**NSLPP MEETING HELD ON 02/03/2022
SECTION 4.55 APPLICATION REPORT**

ADDRESS/WARD: 182 Kurraba Road, Kurraba Point

APPLICATION No: DA 333/19/4

PROPOSAL: Modifications to a Consent for Alterations and Additions to Convert a Duplex into a Residential Flat Building with Strata Subdivision.

Figure 1 – Excerpt of Section A- A drawing No DA_300_00 (Daniel Younan & Assoc)

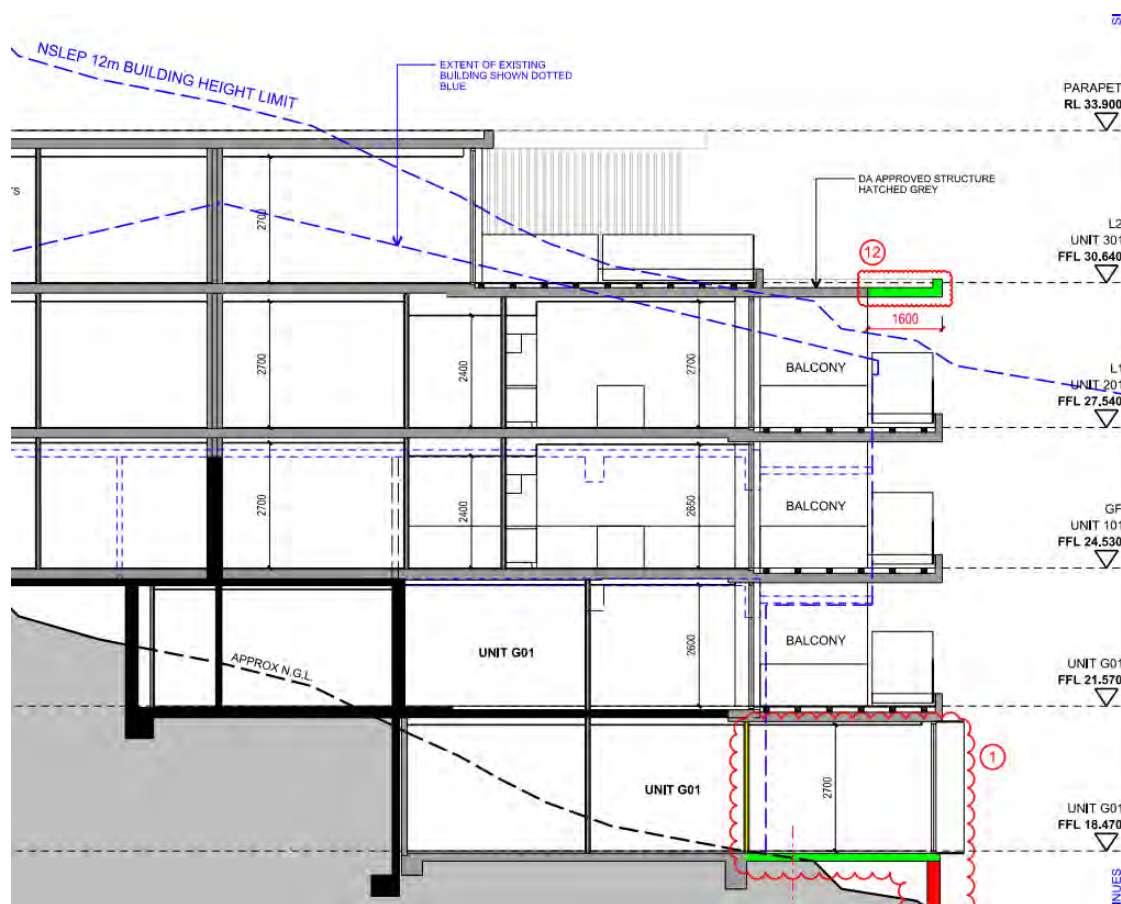
The modified proposal involves a minor projection of the pebble deck roof over the rear balcony of Unit 201, on Level 1, this projection will encroach slightly into the 12m height plane on the northern side of the development. The approved design already involves a breach of the 12m height of buildings standard on part of the north east corner of the roof. The modified proposal involves a minor increase in that breach caused by the roof projection.

The additional breach can be seen in Figure 1 below and its only purpose is to provide better weather protection for the unit below. The top of the roof or deck is non-trafficable.

As no significant impacts will occur as a result of the roof projection, the minor variation would not be inconsistent with the objectives of the standard in terms of compatibility with the local area character, not significantly affecting bulk and scale, and improving amenity for the residents.

Comment: No objection to this extension, and minor height variation, as it will increase weather protection or unit 201.

Figure 2 - 10m & 3.8m wall highlighted yellow on stamped plans for s.4.55 DA 333/19/2 issued 9.6/2021.

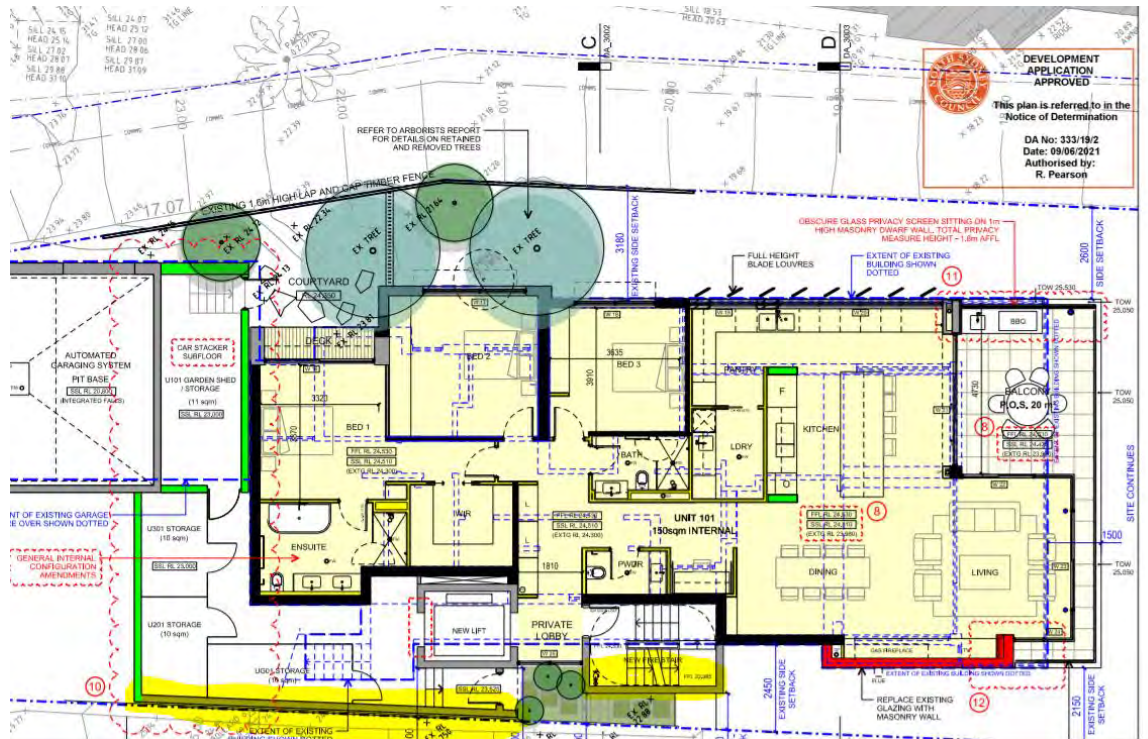
9) **Concern to non-compliant setbacks, 'new' 10m wall on the southern boundary, 'new' 3.8m long wall (fire stairs) setback 900mm to southern boundary.**

Comment: The 'new' 10m wall on the southern boundary and shorter 3.8m wall to the fire stairs were approved in the original DA 333/19 consent and s.4.55 modification. (See Fig 2 below).

Both of the walls highlighted in Figure 2 have been previously approved and not the subject of this current s4.55 modification.
